Millstone Nuclear Power Station, Unit Nos. 1, 2, and 3
Proposed Change to Revision 22 of the
Dominion Nuclear Connecticut, Inc. Quality Assurance Program Topical Report
Independent Safety Engineering Group Reporting Relationship

**Proposed Changes to the Dominion Nuclear Connecticut, Inc.
Quality Assurance Program
Independent Safety Engineering Group Reporting Relationship**

Proposed Changes to Revision 22 of the Dominion Nuclear Connecticut, Inc.
Quality Assurance Program Topical Report, Section 1.0 and Appendix F

Organizational Relationship of Functional Groups
 Having Quality Functions for Millstone Power Station -
Nuclear Technical Services

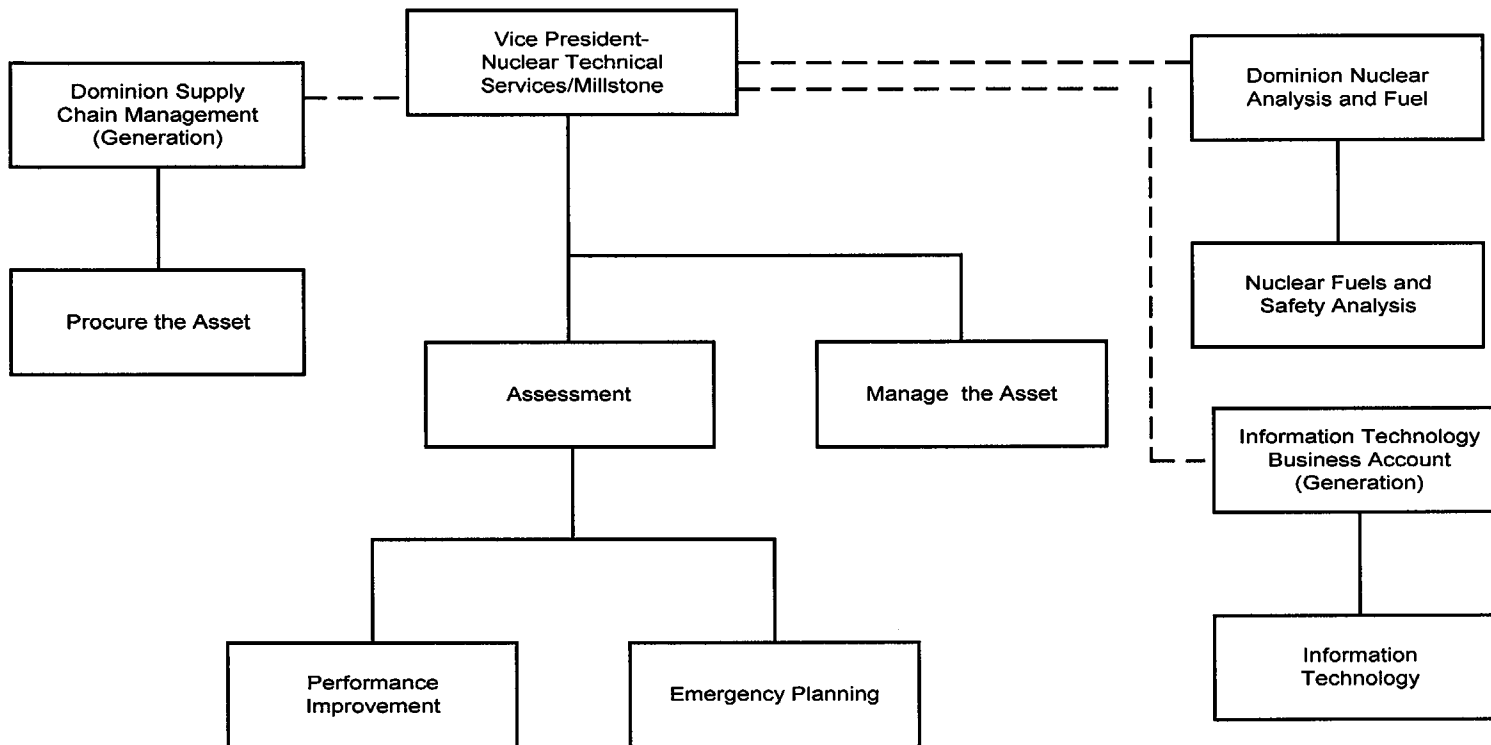
Currently the ISEG Team Lead (supervisor) reports to the Process Owner - Oversight (manager). Implementing the proposed changes with the new organizational scheme results in the ISEG reporting to the Process Owner - Performance Improvement, who together with two other Process Owners, i.e., Regulatory Affairs and Emergency Planning, report directly to a high-level, technically oriented, management position, the Vice President - Nuclear Technical Services/Millstone, who reports directly to the Vice President and Senior Nuclear Executive - Millstone. The Vice President - Nuclear Technical Services/Millstone (an Officer) is not in the direct chain of command for power production. Therefore, this reporting relationship provides the ISEG with direct access via their process owner, the PO - Performance Improvement, to the Vice President - Nuclear Technical Services/Millstone.

1.3.13.2 Performance Improvement is responsible for the Corrective Actions Program **and Independent Safety Engineering Group and Operating Experience Program.**
